TECHNICAL BULLETIN 2010 - 2 PISTON IMPLEMENTATION: JUNE 30TH 2010

Sub-Section 3.1 of the 2010 Technical Regulation in sections **9.1 Technical regulation (within the engine seal) for ROTAX kart engines 125 Junior Max and 125 Max** and **9.4 Technical Specifications (within the engine seal) for ROTAX Kart engine 125 MAX DD2** are replaced by the following:

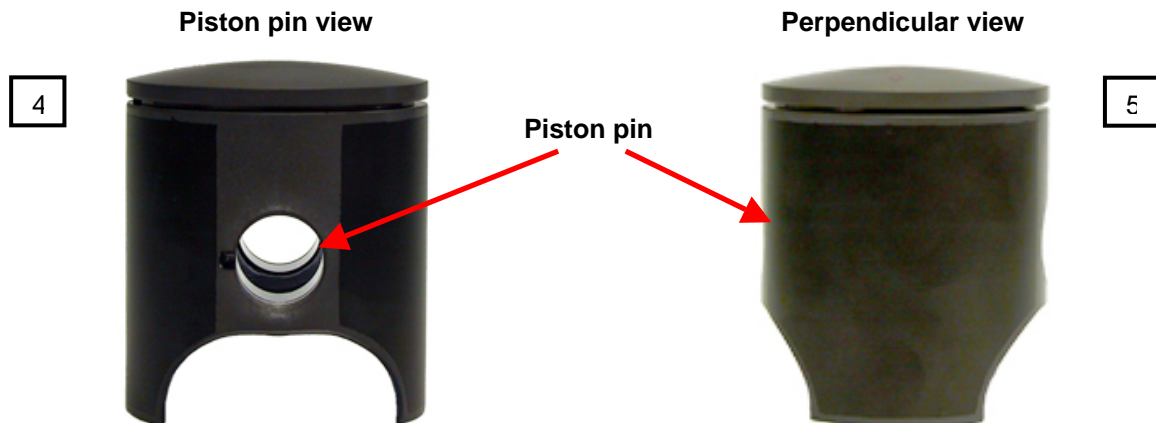
3.1. Original coated aluminum cast piston with one piston ring. The piston must show on the inside the cast wording "Elko" (1) and "Made in Austria" (2). The piston must show an identical shape on both sides of the piston pin and must be of identical shape on the front and the back of the piston as shown on the perpendicular view below:
